Marketing Device Connection Technology
Thorsten Grandt
May 29, 2013

Change of the MSTB(A)L 2,5/...-G(F)... header
Please forward this information to your electrotechnical departments!

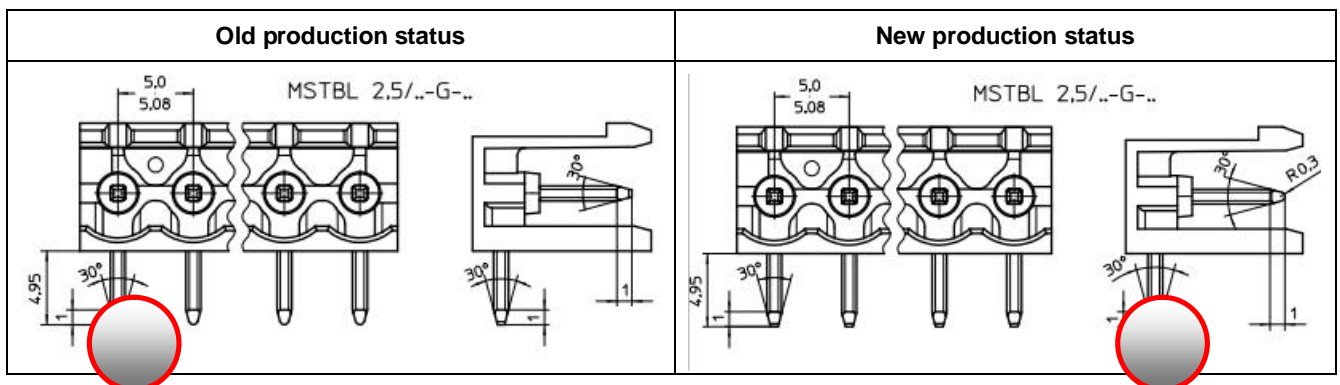
In order to be able to manufacture the header optimally, the solder pins will be slightly changed. The tips of the radius tread R 0.3 will be rotated by 90°. This means that, until now, the radius has been visible in the front view. Now, it can be found at the side. The technical features are not affected by this change.

The new version is expected to be delivered as of November 29, 2013.
